UNITED STATES PATENT AND TRADEMARK OFFICE

Office Action Summary

10/667,602

DETAILED ACTION

【図1】

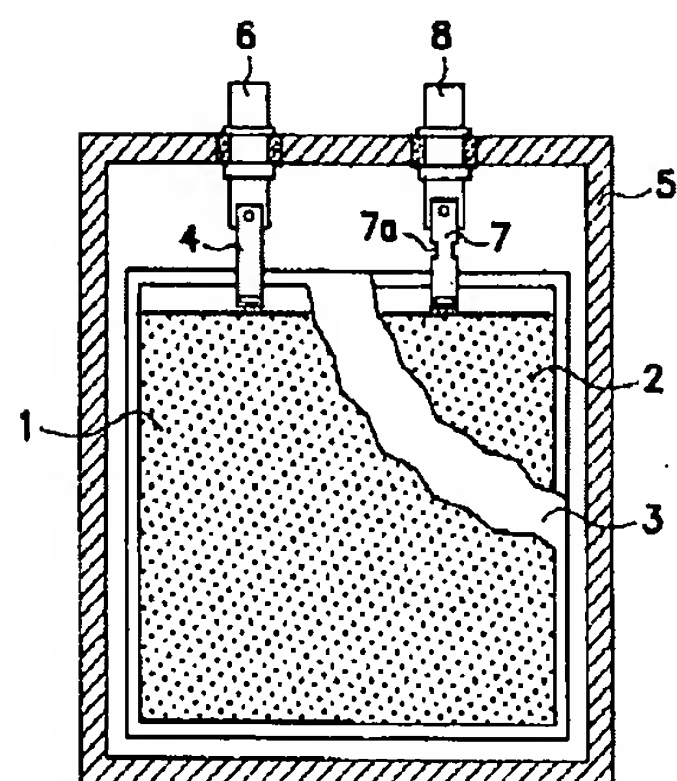
The JP'614 discloses an electrode assembly comprising a positive electrode 1 and a positive electrode lead 4; a negative electrode 2 and a negative electrode lead 7 (P. 0002/ CLAIM 1/FIGURE 1). The electrode assembly is a laminated (stacked) and wound assembly (P. 0011).

Figure 1 below illustrates the specific configuration of the electrode assembly:

A constricted portion 7a is made at the center between an upper and lower side of the negative electrode lead 7 (ABSTRACT). Accordingly, as for the negative electrode, the constricted portion 7a sets a current limit (ABSTRACT/ P. 0014-16).

【図2】

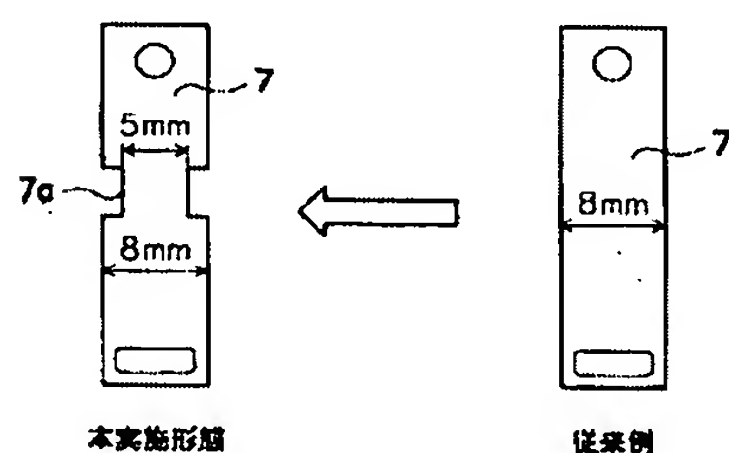
Figure 2 below also illustrate constricted portion 7a having at least a curved portion forming a substantially right angle on the negative electrode lead 7.

As shown in **Figure 2**, section 7a has a smaller cross-sectional area than a cross-sectional area of the negative electrode lead (See Figure 2). *As can be appreciated from the illustration of Figure 2 below, the cross-sectional area of the constricted portion 7a is smaller than the cross-sectional area of the adjacent portions.*

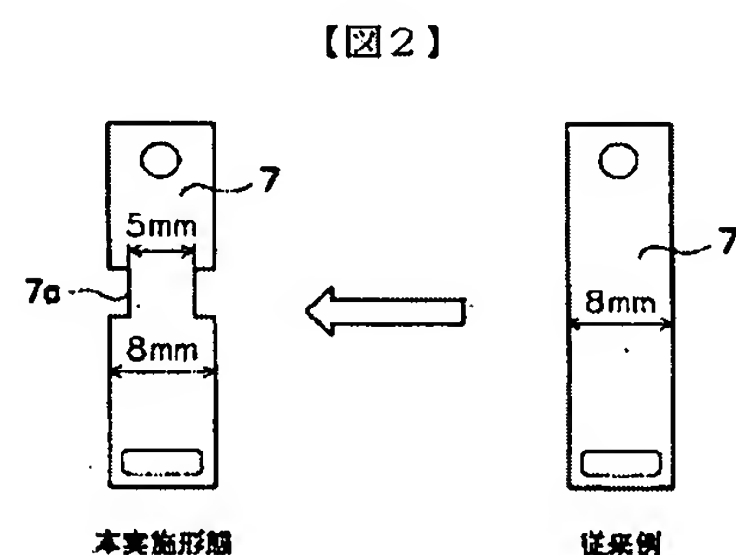
It is apparent from **Figure 2** above that section 7a forms a notch and/or an indentation and/or an angular cut in the edge (See Figure 2).

At least, the cross sectional area near section 7a can be represented by 5 mm x L, while the cross sectional area of the negative electrode can be represented by 8mm x L (See Figure 2).

Thus, the cross sectional area near section 7a is about 0.625 times that of the cross sectional area of the negative electrode.

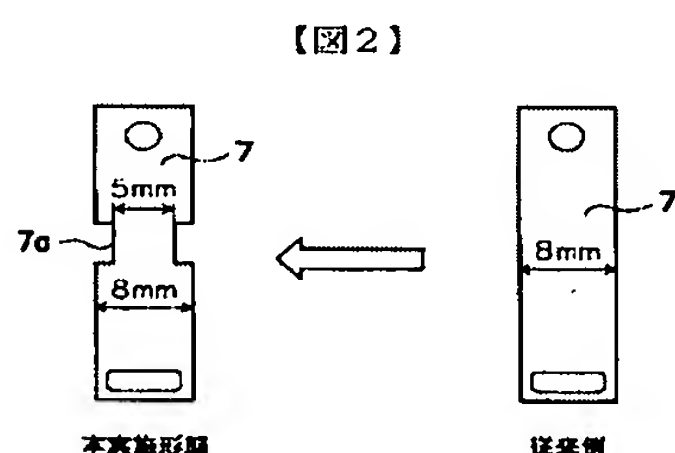
9. Applicant has now advanced the argument that the newly added limitation “*the current collector is arranged in a curved portion of the negative electrode lead*” is neither disclosed nor taught by the prior art reference. The examiner respectfully traverse this argument. For instance, Figure 2 below illustrates constricted portion 7a having at least a curved portion forming a substantially right angle on the negative electrode lead 7.
